Field Memo

Date Submitted:	12/3/2024	**Field Memo #:**	**023**
Contract Name:	RapidRide J Line BRT (Re-Bid)	**PW #:**	2023-002
Contractor:	Jansen, Inc.	**Fed Aid #:**	WA-2024-012-00 WA-2024-013-00 WA-2023-070-00

Subject: Fairview Staging Yard Noncompliance

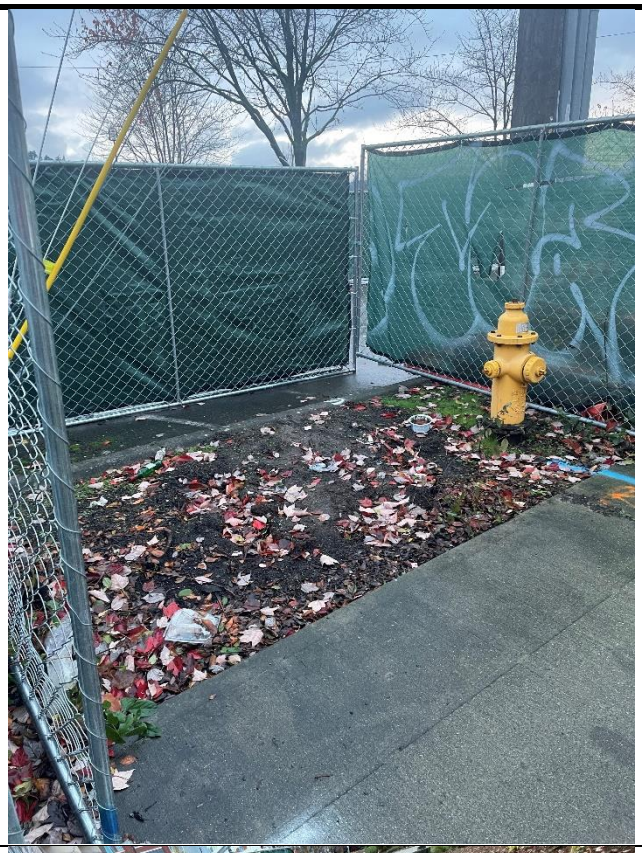
Issue: Hydrant Clearance **Corrective Action:** Provide a minimum 3' clear around hydrant **Reference**: Seattle Fire Code 507.5.4: *Obstructions Unobstructed access to fire hydrants shall be maintained at all times. The fire department shall not be deterred or hindered from gaining immediate access to fire protection equipment or fire hydrants.* Seattle Fire Codes 507.5.5 Clear space around Hydrants: *A 3 foot clear space shall be maintained around the circumference of fire hydrants, except as otherwise required or approved.* Streets Illustrated Section 3.3 Clearances: Fire Hydrant clearance to the closest part of any fixed object is 5'.

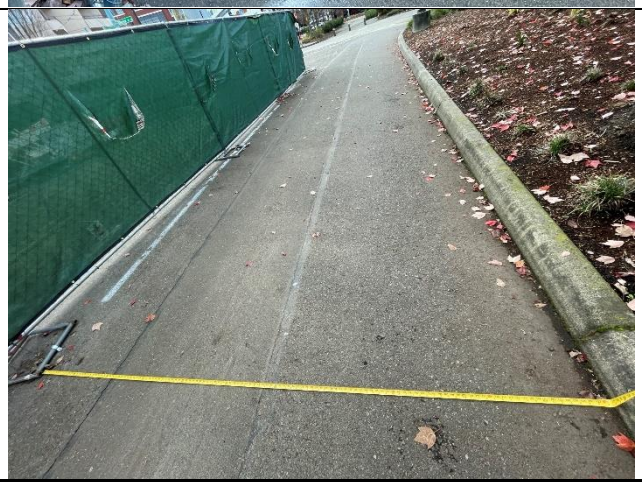
Issue: At several locations the fence encroaches into the drive lane **Corrective Action**: Relocate the fence so the footing and the fence maintain 11' clearance from the curb. **Reference**: Street Illustrated Section 3.1 Travel Lanes adjacent to curb is 11 feet minimum

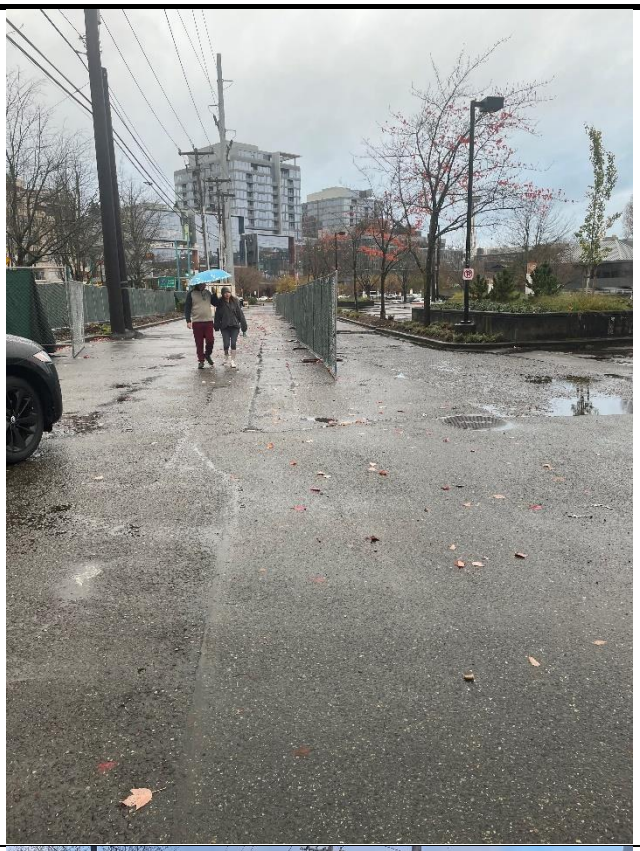
Issue: Staging area not secured **Corrective Action**: While not in use the contractor must secure the staging area properly to prohibit bikes, pedestrians, and vehicles from entering the staging area. **Reference**: Special Provision 1-10.2(5)H *Temporary chain link fence must be used to secure these long-term staging areas*
